**Request**  
**Project Name**  
**Council District**  
**Requested by**

**DTC Modification**  
**701 8<sup>th</sup> Avenue South**  
19 – O’Connell  
Brendan Boles, Kimley-Horn Associates

# Downtown Code DRC Meeting of 9/2/2021

Figure 1: Site Plan

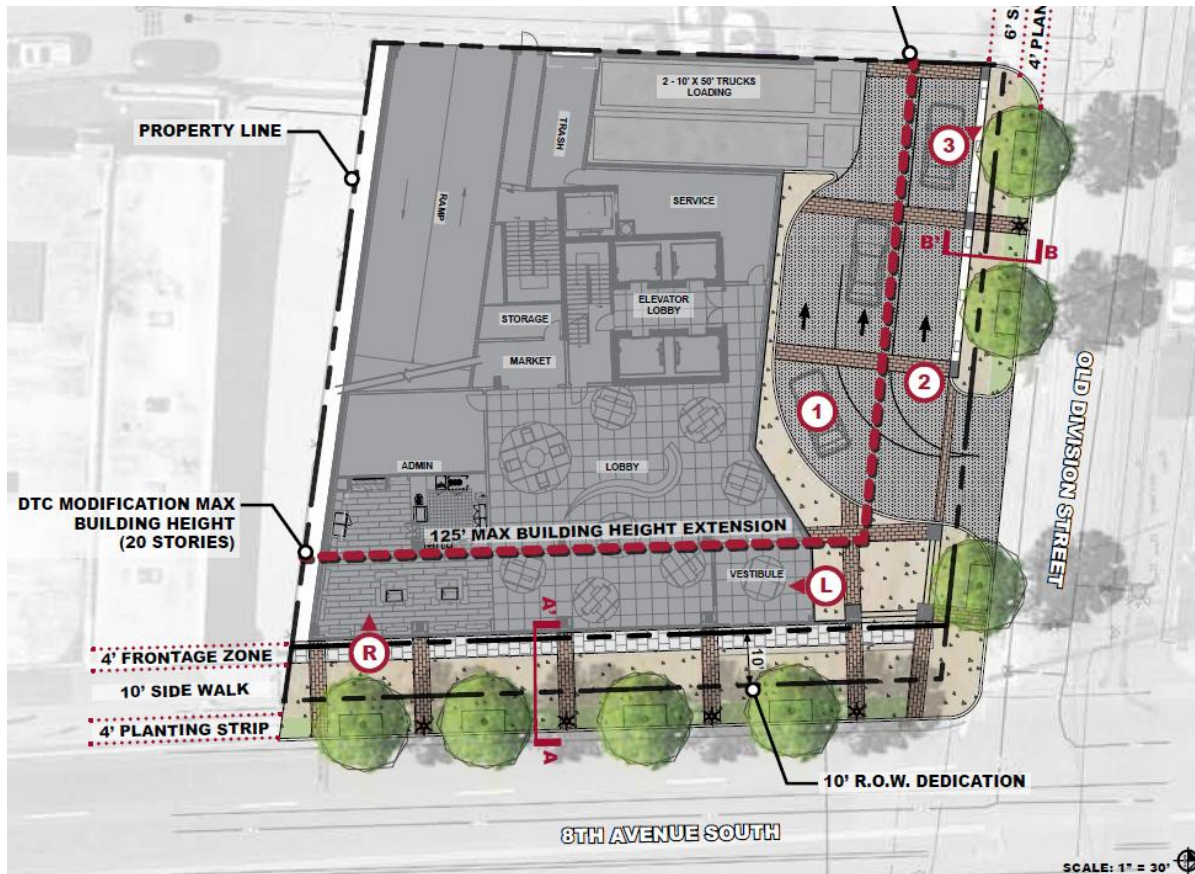
This applies to frontage 150’ from the key intersection. The property in question has approximately 4.25’ of frontage within 150’ of the intersection and is requesting to apply the 20-story height at key intersections entitlement to remainder of the property.

The intent of this standard is to frame important intersections with additional height. The property does not touch the intersection of 8<sup>th</sup> Avenue South and Division Street and has a mere 4.25’ of frontage within the 150’ radius from that intersection. Expanding the amount of applicable frontage from 4.25’ to 123.05’ on the basis that the height is marking the important intersection is not consistent with the intent. Additionally, the proposed design has significant issues, including a bulky massing with four levels of unlined structured parking with a ubiquitous use of “synthetic stucco”.

Staff recommends disapproval of the application as submitted.
